# REGULATORY INFORMATION DISTRIBUTION SYSTEM (RIDS)

SUBJECT: Forwards comparison of draft STS w/snubber functional test sampling plan.

Re: Snubber Functional Test  
Sampling Plan

# SNUBBER FUNCTIONAL TEST SAMPLING PLAN EVALUATION

Expected Average Number  
Tested 96% of the Time

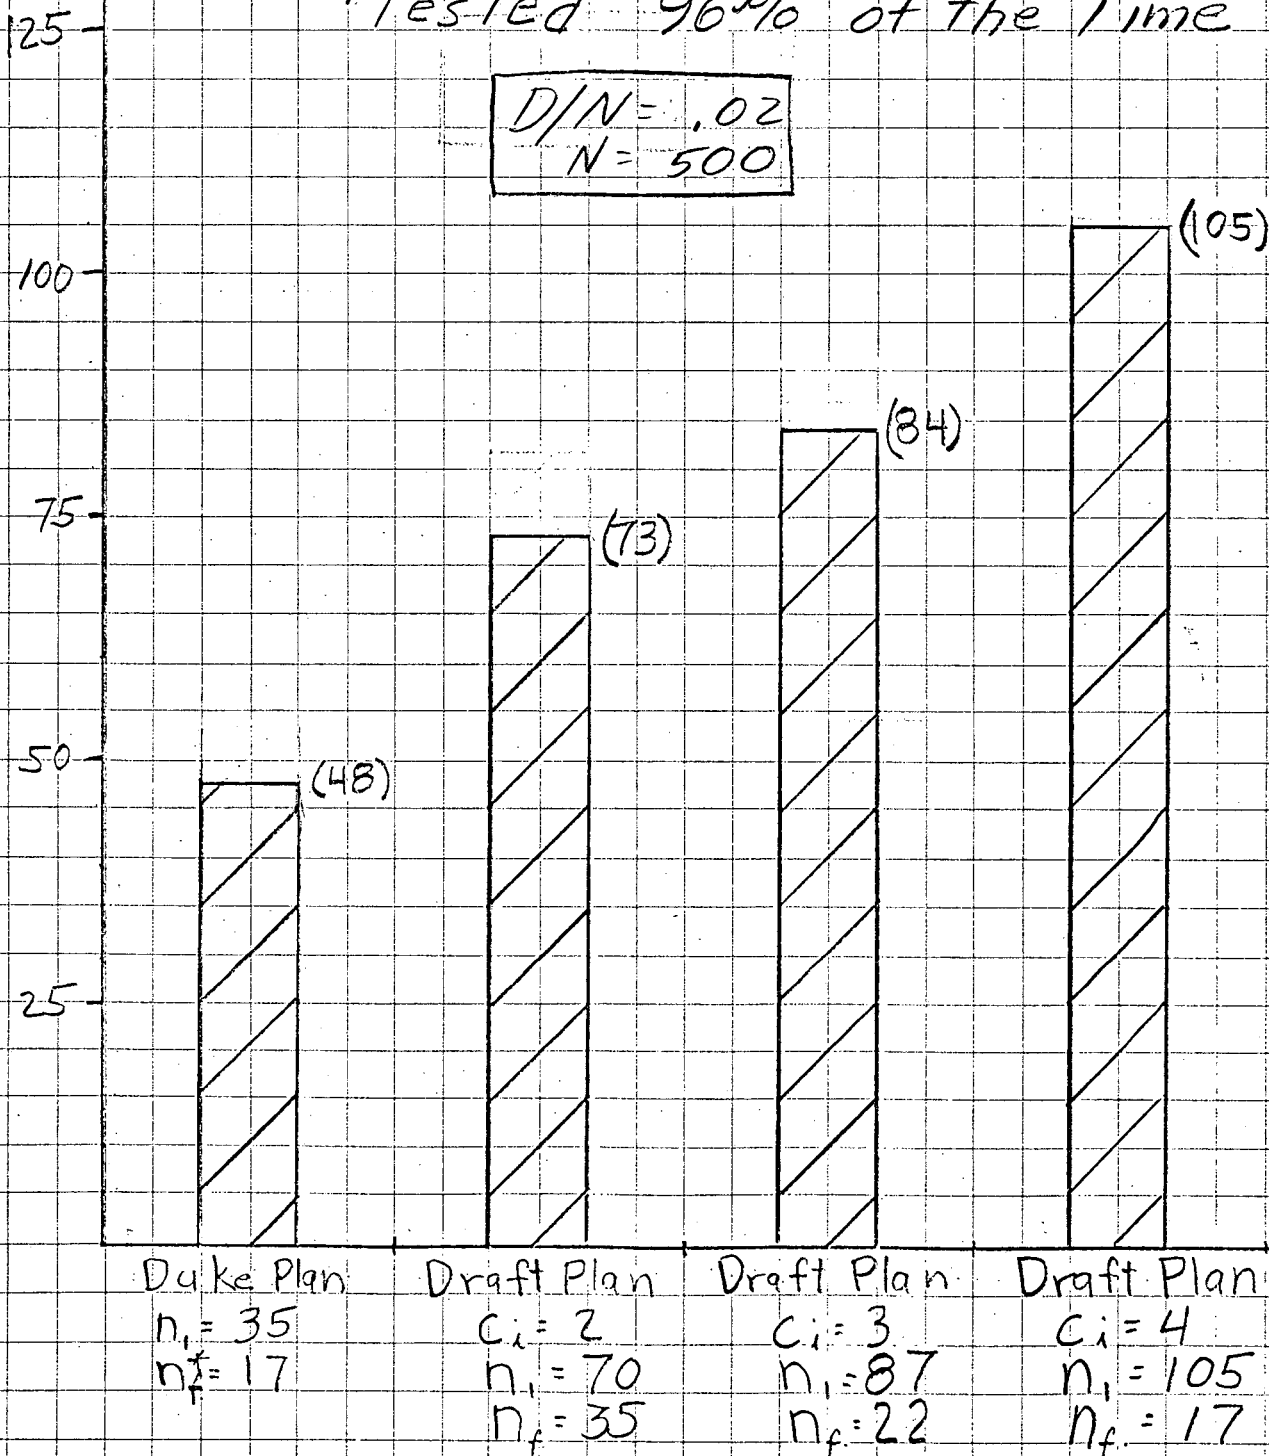
Figure 5 shows the probability of testing exactly a given number for each plan under consideration. Using this information, Figure 6 has been developed which shows the expected average number of snubbers tested 96 per cent of the time. The remaining four per cent are those low probability cases requiring a large amount of testing. As can be seen from Figure 6, the Duke plan will average 48 snubbers tested while the draft plans require averages of 73, 84, and 105 respectively.

Our conclusion is that the Duke plan is considerably more effective than all of the draft plans in minimizing costs.
